Project	IEEE 802.16 Broadband Wireless Access Working Group < http://ieee802.org/16 >	
Title	Action Item from Session #48: MAC messages text update for credit token based coexistence protocol	
Date Submitted	2007-05-09	
Source(s)	David Grandblaise Motorola Labs Parc Les Algorithmes Commune de Saint Aubin 91193 Gif sur Yvette, France	Voice: +33 (0)1 6935 2582 Fax: +33 (0)1 6935 4801 mailto: david.grandblaise@motorola.com
Re:	Working Group Letter Ballot #24a for IEEE P80216h/D2a	
Abstract	During sessions # 47 and # 48, several comments (2127, 2152L, 2153L) were made to update and clean up text related to MAC messages for the credit token based coexistence protocol. This contribution provides some text remedy proposals for these comments, and consolidates the previous preliminary contribution [3].	
Purpose	Action Item from Session #48: MAC messages text update for credit token based coexistence protocol

Action Item from Session #48: MAC messages text update for credit token based coexistence protocol

Figure hb: Inter system over the air communications messages for CT-CXP operations

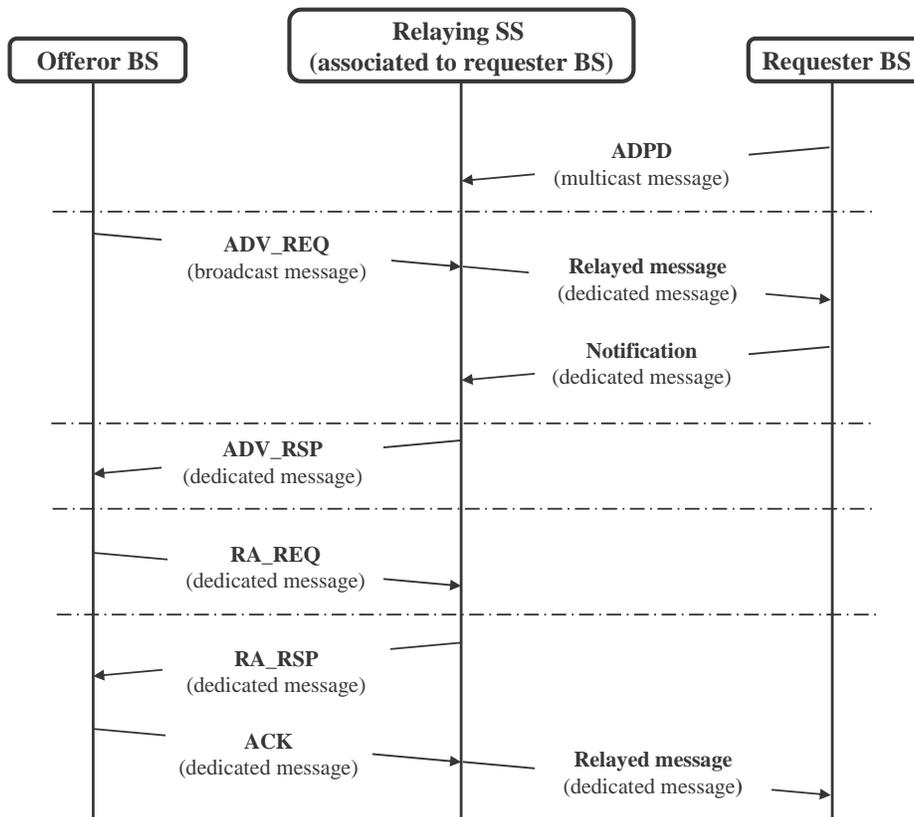
[Create a new clause 15.x as indicate:]

Figure hb describes the over the air communications messages between the offeror and requester for CT-CXP operations. The messages between the offeror BS and requester BSs are conveyed through SS(s) acting as relay between the offeror and requester BSs. Each relaying SS is associated to the requester BS and is in the overlapping coverage of the offeror and requester BSs. The relaying SS can receive and decode messages from both its serving BS (requester BS) and the foreign BS (offeror BS), and can send transmit message to both offer or and requester BS.

ADPD message (Advertisement Discovery Policy Descriptor) is sent from the home requester BS to its associated relaying SSs as a regular multicast data message. Purpose of ADPD is to instruct the attitude of each relaying SS when it receives ADV_REQ message. ADPD specifies whether the relaying SS has to relay ADV_REQ message toward its serving BS (requester BS). If the content ADV_REQ message meets the requirements instructed in ADPD, the relaying SS actually relays ADV_REQ message from the offeror BS to its serving BS (requester BS). Otherwise, it does not. That way, ADPD rules the transmissions from any relaying SS towards its serving BS. This mechanism avoids having incessant transmissions from the relaying SS towards its serving BS when renting conditions proposal specified in ADV_REQ does not meet the requester BS's need. Any policy can be established and can be adapted dynamically in time by the requester.
